Town of Hilton Head Island  
**Design Review Board Meeting**  
**Tuesday, May 11, 2021 – 1:15 p.m.**  
**AGENDA**

i. Wei Food Hall Facades, DRB-001076-2021

**PROJECT: Wei Food Hall Facades**

## DESIGN TEAM/DRB COMMENT SHEET

Landscape Plan  
**PORT ROYAL PLAZA**  
**96 MATTHEWS DR.**  
 Hilton Head Island, South Carolina

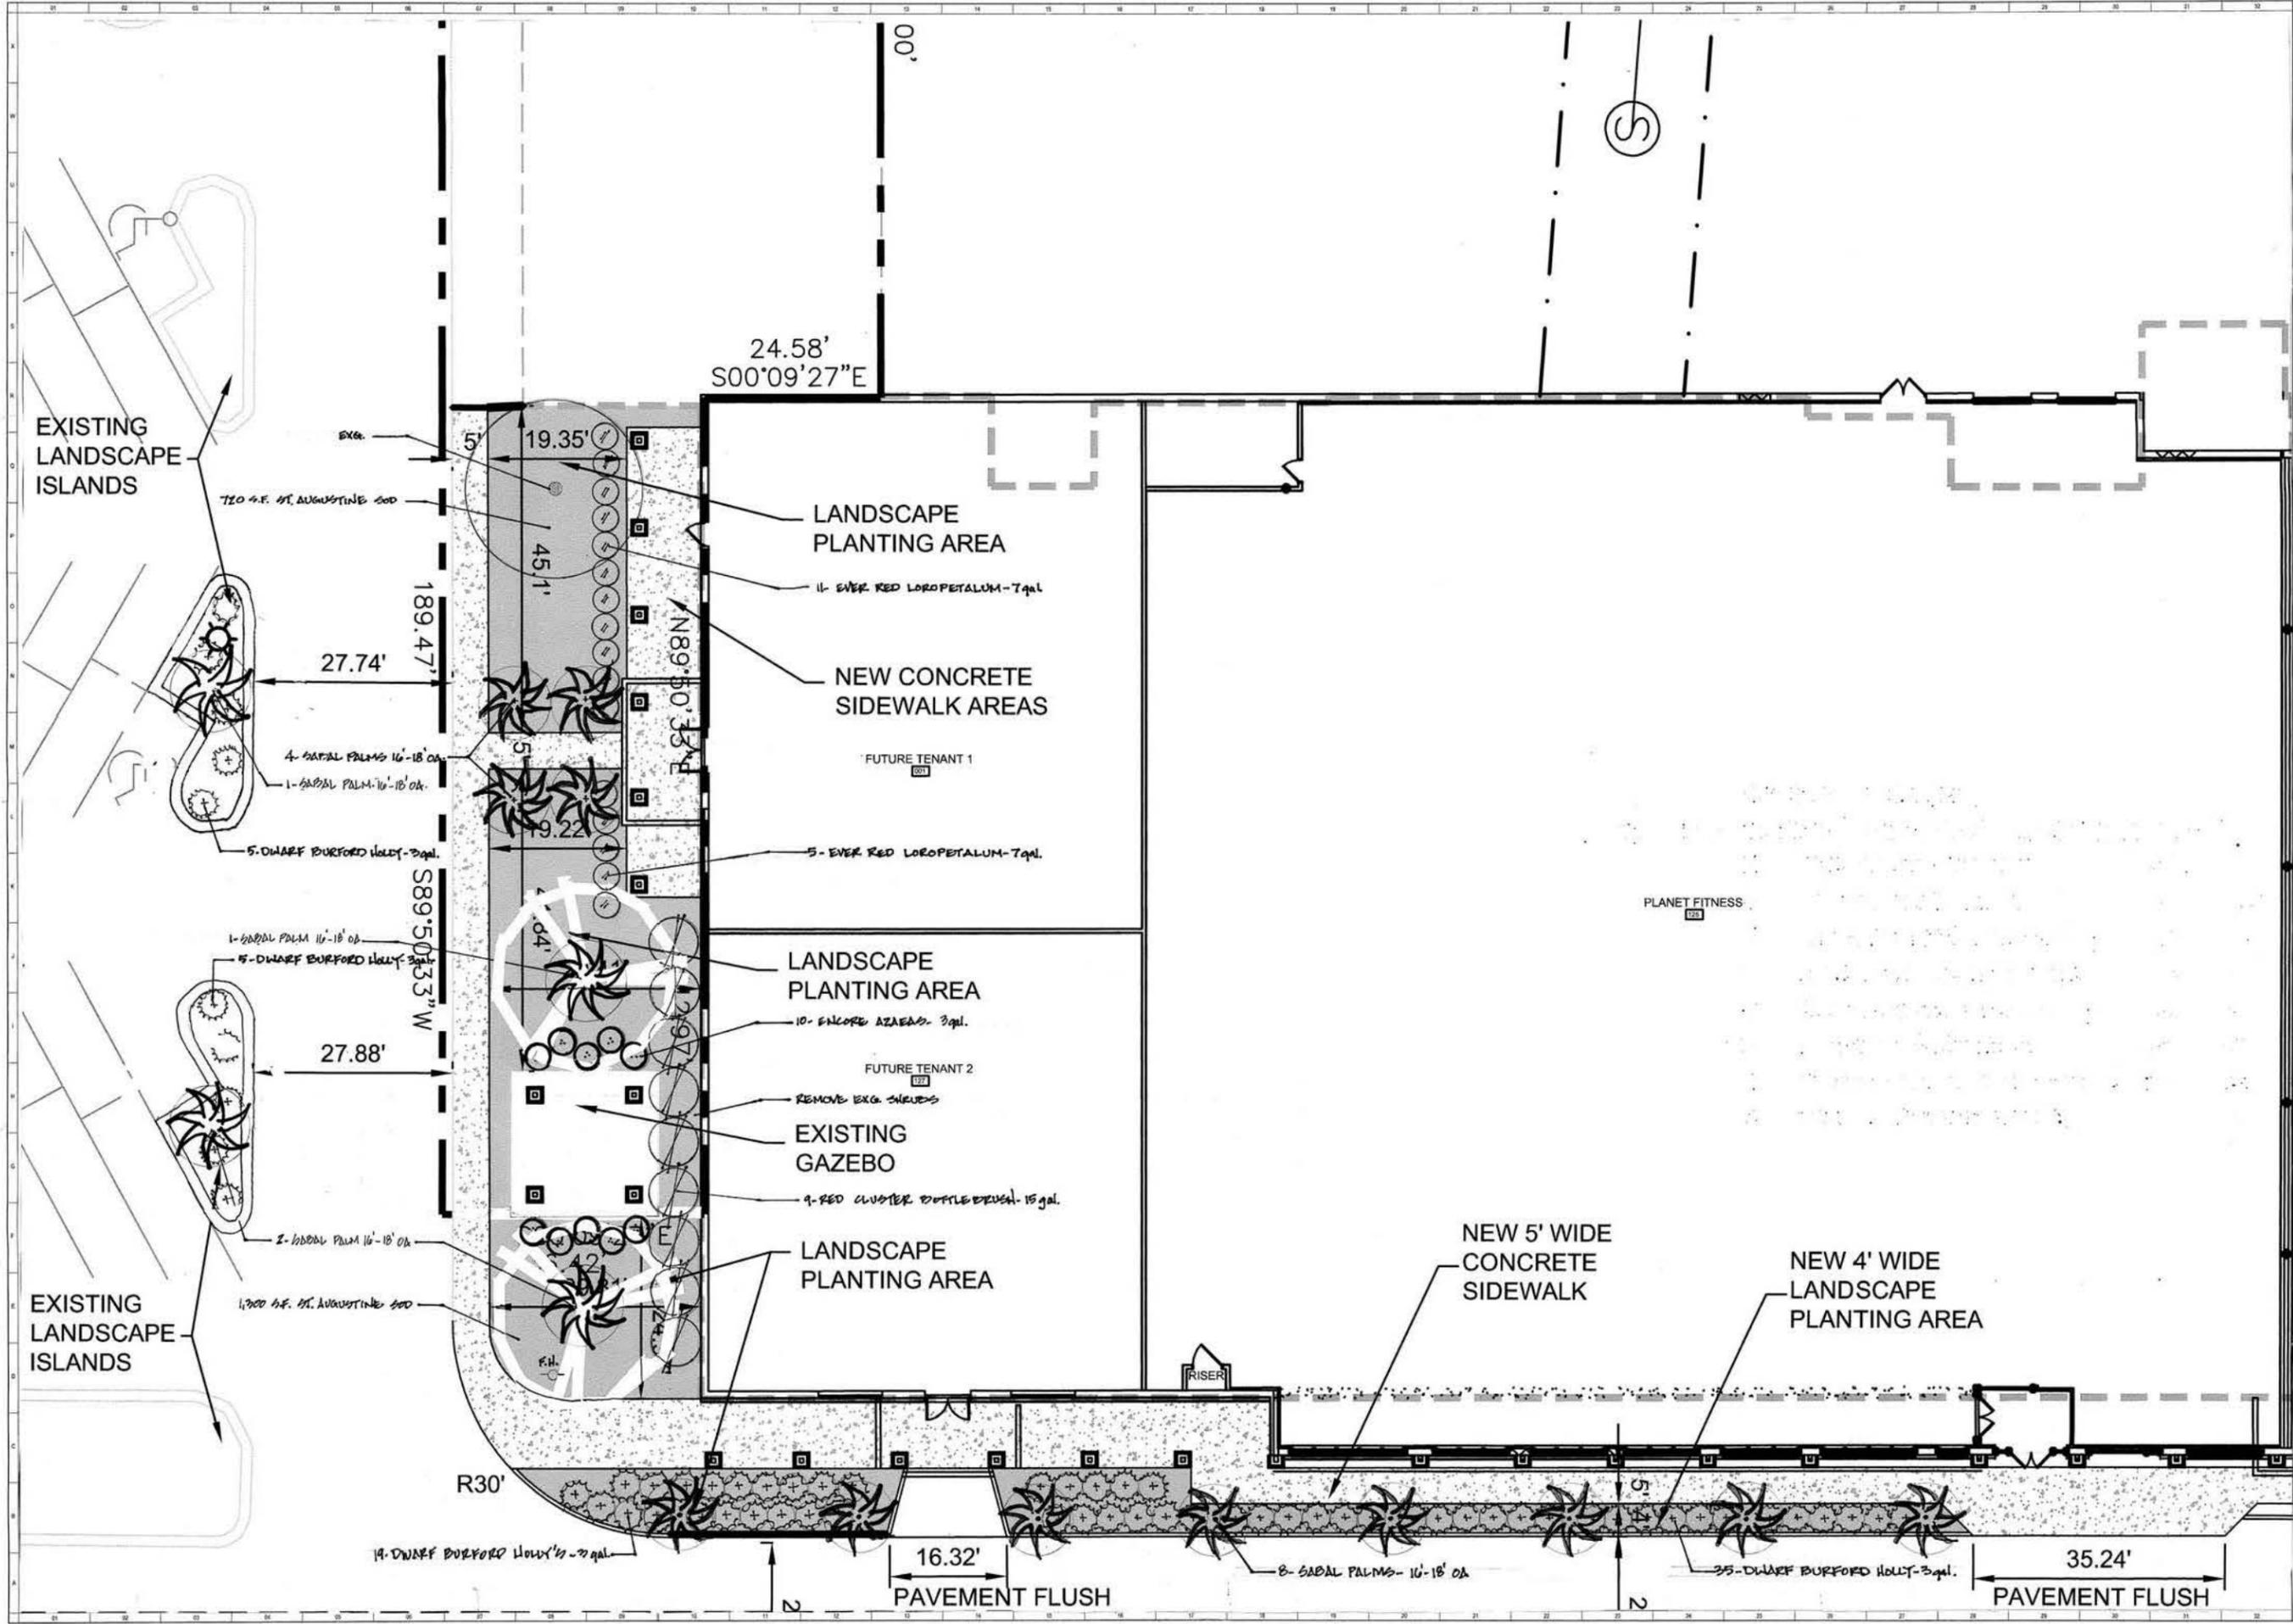
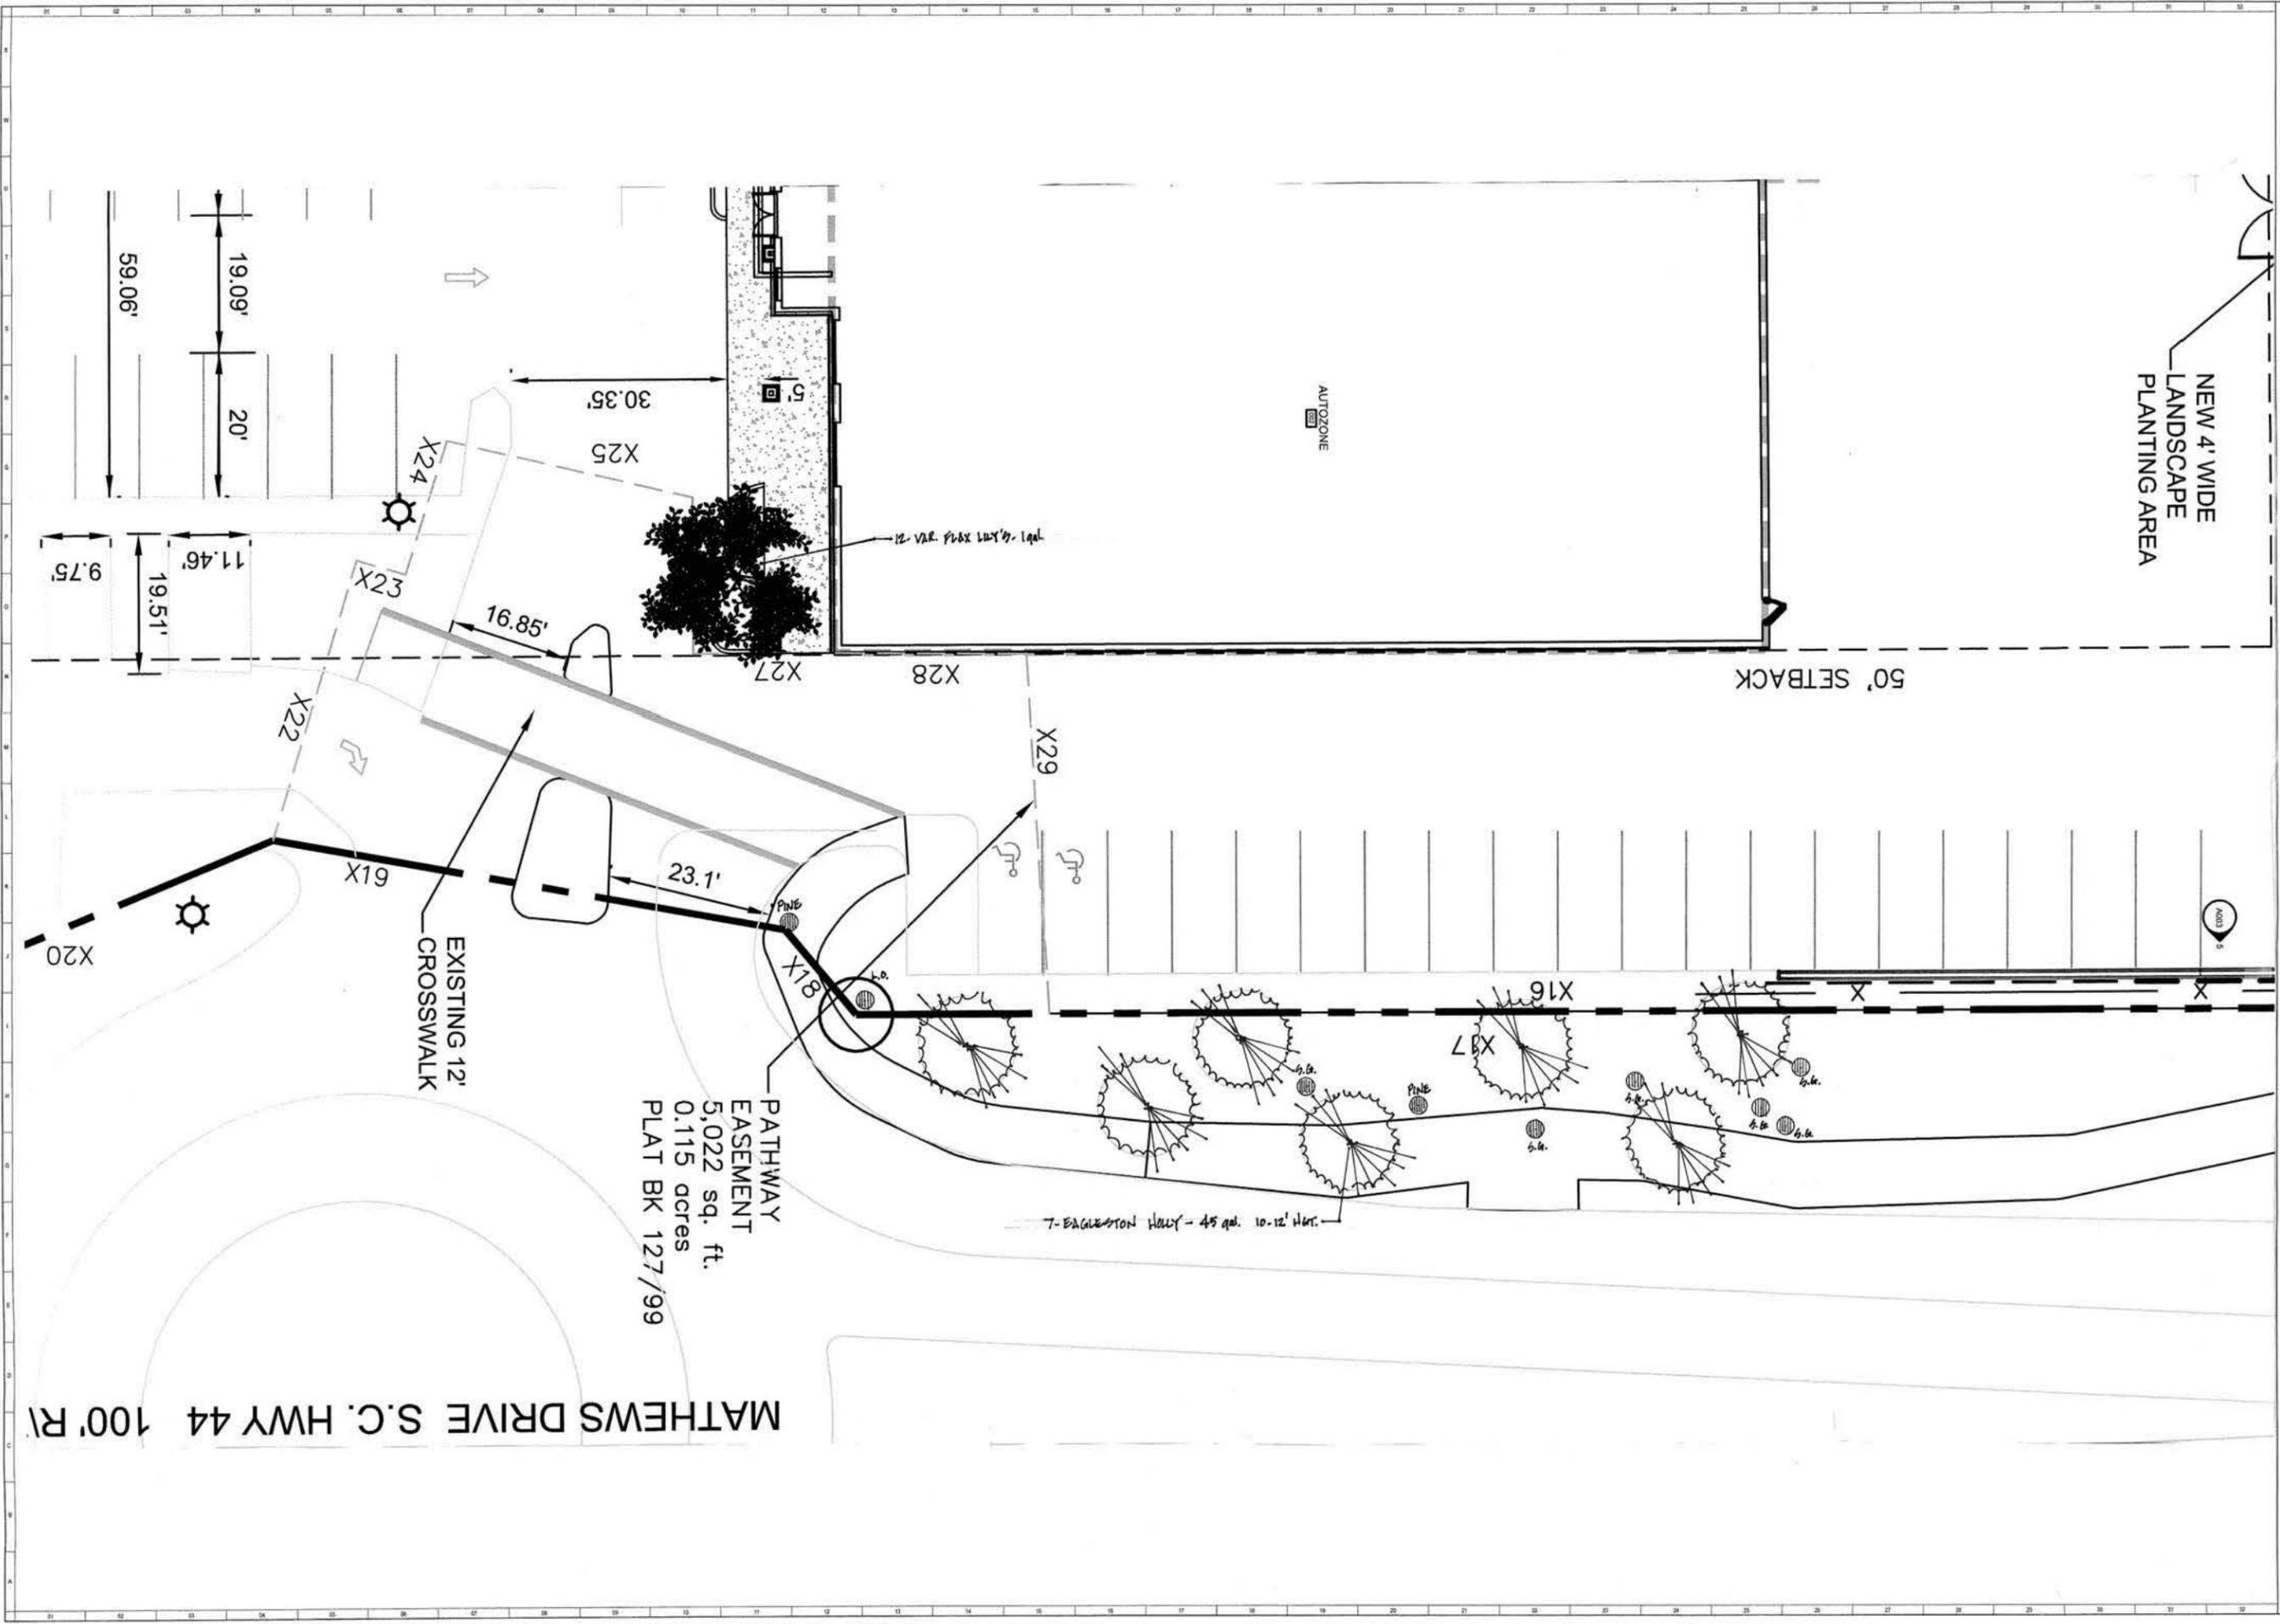
1. Provide Site Plan for review by Staff that address the following:
  - a. Dimensions of the proposed changes to the drive aisle and landscape area addition.

- b. Reconsideration of the pedestrian access through the new landscape area.
  - c. Specify / label the curb or other protection of the landscape area on the plans.

2. Revision of the Planting Plan for review by Staff that address the following:
  - a. Add additional (palms, hollies, etc.) to the landscape area between the building and the drive aisle.

- b. Planting appears thin between the building and the drive aisle.
  - c. Add taller plants along wall behind existing gazebo to break up the expanse of the wall.

3. Provide an updated site plan for review and approval by Town Staff and one DRB landscape architect
4. Within the beds at the front of the planet fitness building, the muhly grass and loropetalum shall be substituted with low evergreen shrubs.

5. The plantings along the eastern side of the building include a 4” caliper live oak on the corner
6. The two live oaks on the eastern side within the parking lot islands be increased to 4” caliper

7. Remove the Bradford pears and replace with sabal palmettos to match those that are being installed at the front of the building. The spacing and location of those shall be reviewed and approved by Town Staff and one DRB landscape architect.

8. The new plantings within the planting aisles shall maintain a 3’ clear area around the parking spaces.
9. Provide plant sizes in the planting schedule.

10. Replace jack frost Ligustrum with another more adaptive evergreen shrub.
11. Replace the wax myrtles in the parking lot with a dwarf variety shrub.
12. Provide site and architectural plans of what the eastern side will look like with and without a tenant.
